RNTPC Paper No. A/YL-KTN/886B
For Consideration by
the Rural and New Town
Planning Committee
on 13.10.2023

APPLICATION NO. A/YL-KTN/886

<u>Applicant</u>	:	Future Electronics
<u>Site</u>	:	Lot 1471 S.B (Part) in D.D. 107, Shui Mei Tsuen, Yuen Long, New Territories
<u>Site Area</u>	:	About 1,430 m ²
<u>Lease</u>	:	Block Government Lease (demised for agricultural use)
<u>Plan</u>	:	Draft Kam Tin North Outline Zoning Plan (OZP) No. S/YL-KTN/10
<u>Zoning</u>	:	"Agriculture" ("AGR")
<u>Application</u>	:	Proposed Public Utility Installation (Solar Photovoltaic System) and Filling of Land

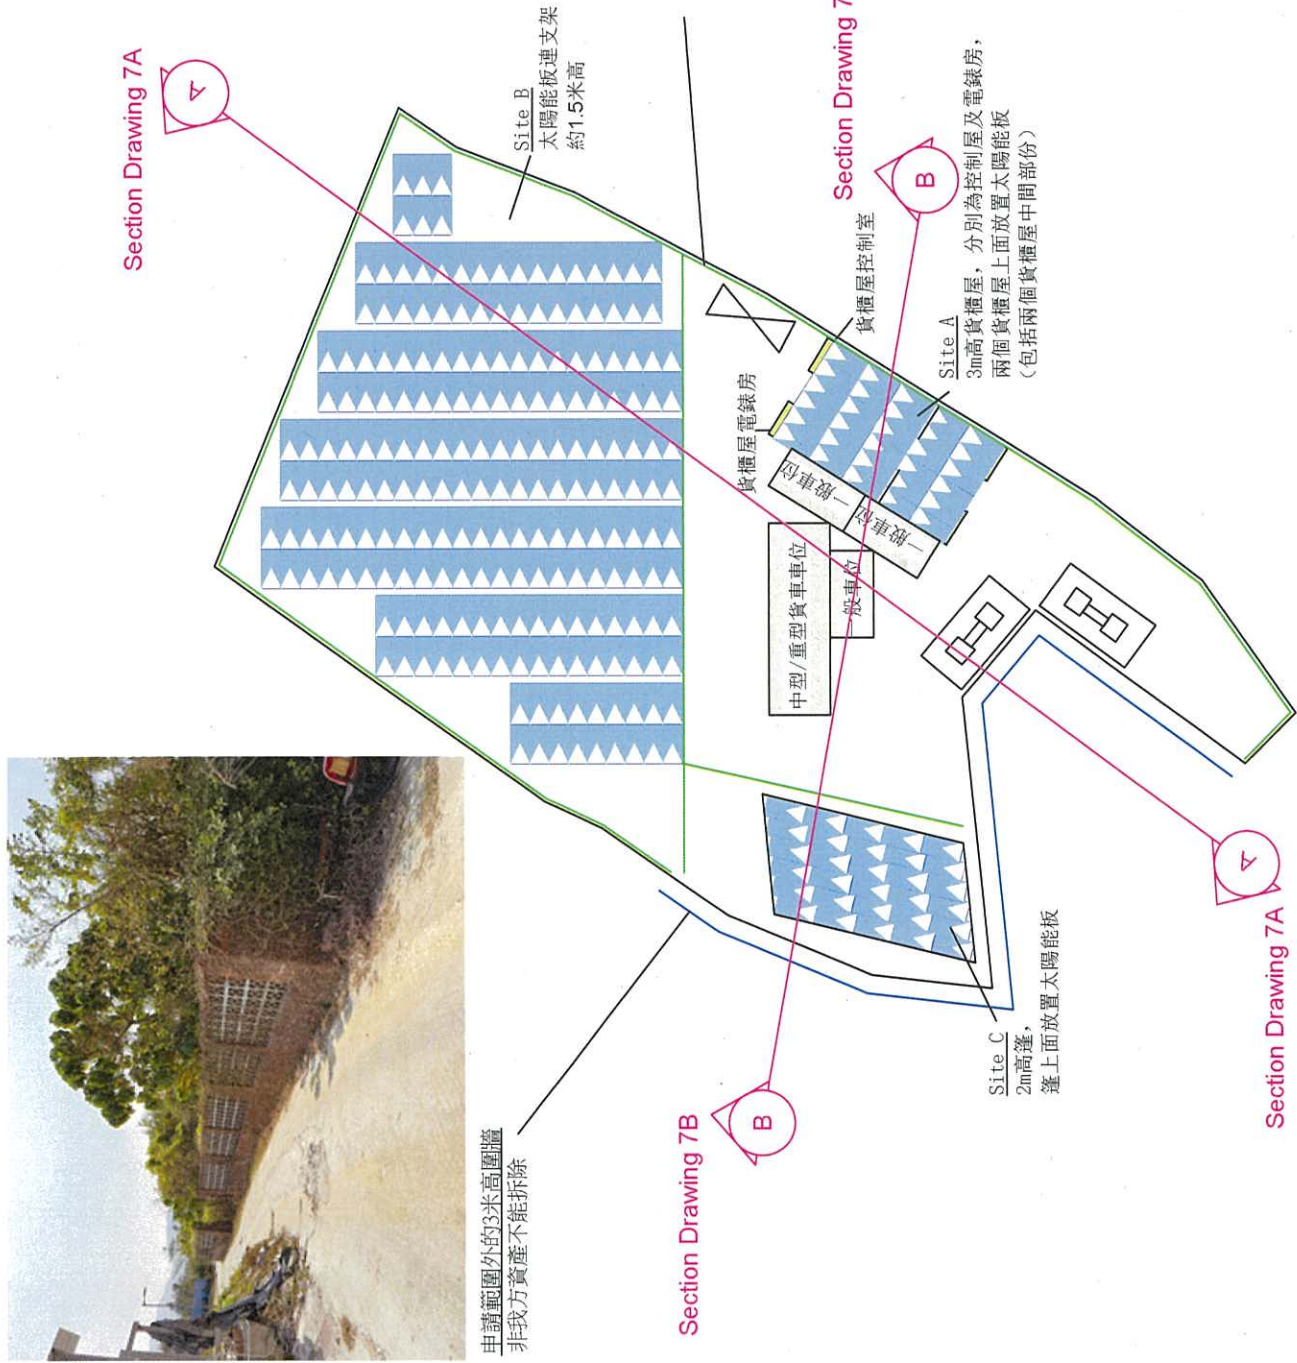
e. The applicant is advised to submit information including section drawing to demonstrate how the proposed solar energy system and other proposed structures would not result in significant adverse visual impact to the surrounding area, as well as provide any mitigation measures as appropriate.

According to the Further Information provided by the applicant dated 5.5.2023, the solar panels will be installed at a height of 1.5m at Site B which is considered as a reasonable height for solar panel systems. But at Site C, the solar panels will be mounted at a height of 3m which is considered rather excessive. The applicant shall re-consider reducing the system height at Site C to 1.5m.

Figure 5, sample picture of solar panel with bracket of 1.5m high and vegetation. (Site B)

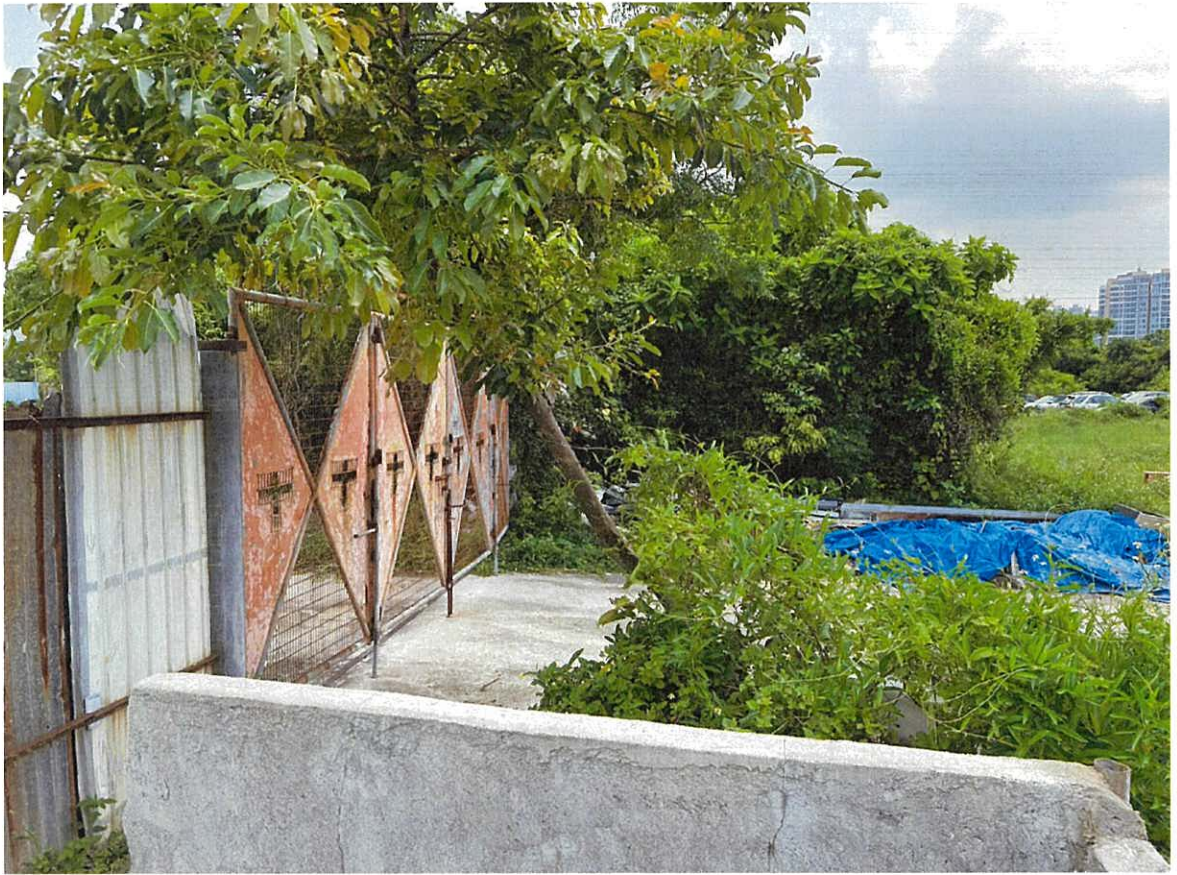
- (a) the Director of Agriculture, Fisheries and Conservation (DAFC) did not support the proposed development from agricultural perspective;
- (b) with reference to Figure 5 in Appendix Ic of the Paper which indicated the proposed design of the SPV panels and vegetation underneath, there were concerns on the practicality of the planting proposal as the shading effect from the SPV panels might result in insufficient sunlight for the plants (even for couch grass as proposed by the applicant); and
- (c) the proposal submitted by the applicant should be practical and implementable. No unrealistic claims or misleading information should be submitted to the Committee.

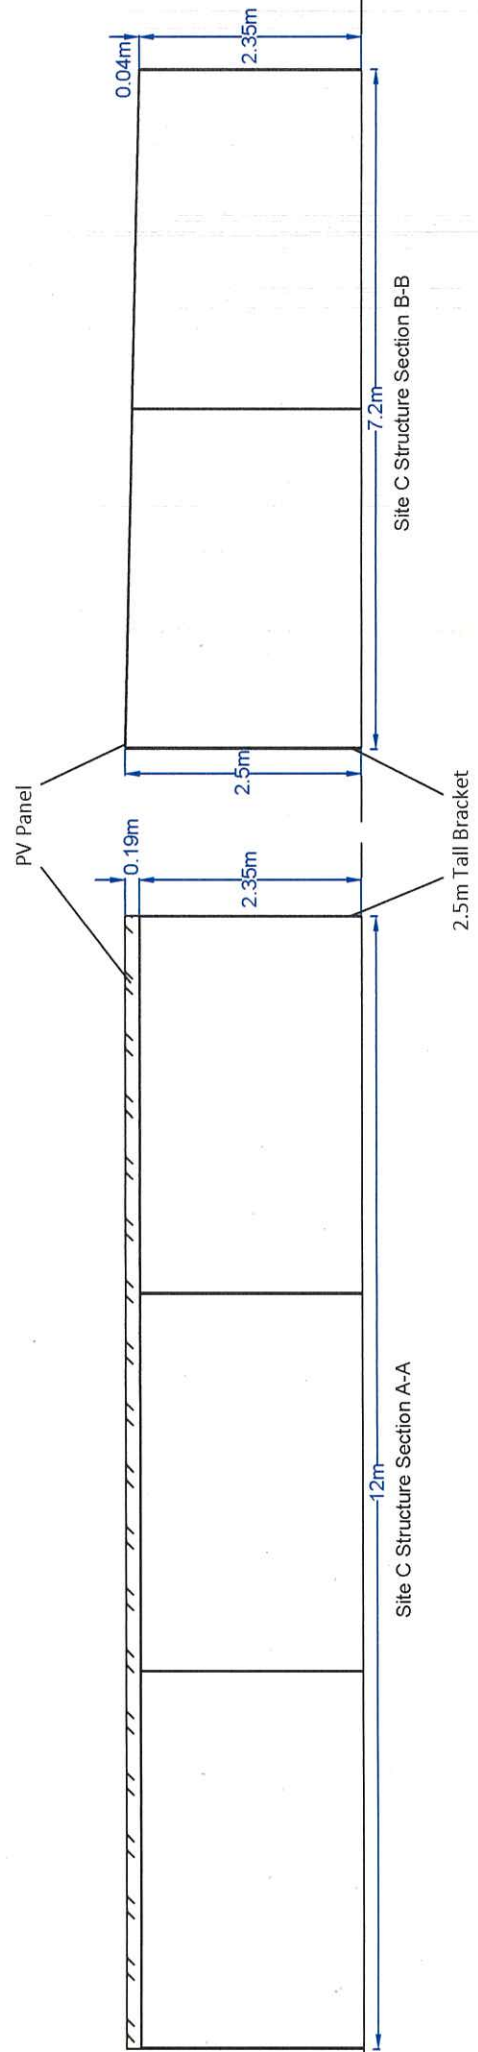
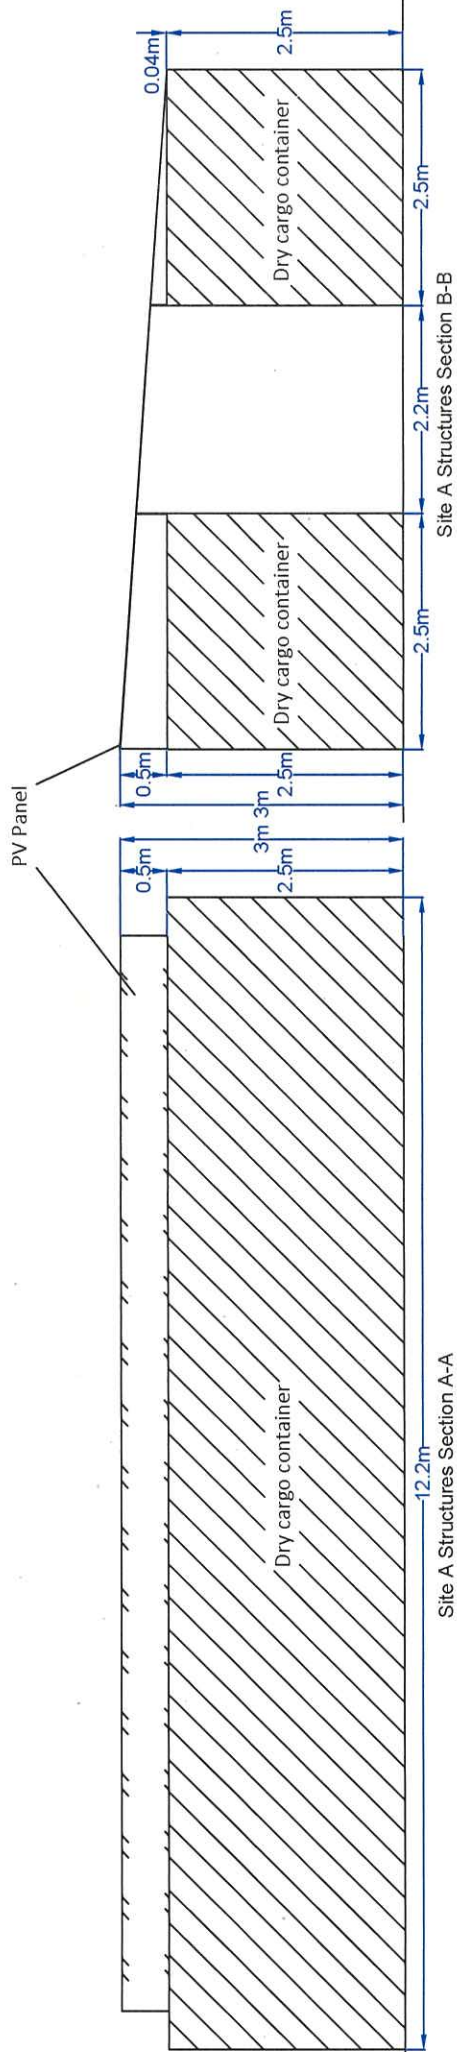
excessive. The applicant shall re-consider reducing the system height at Site C to 1.5m.
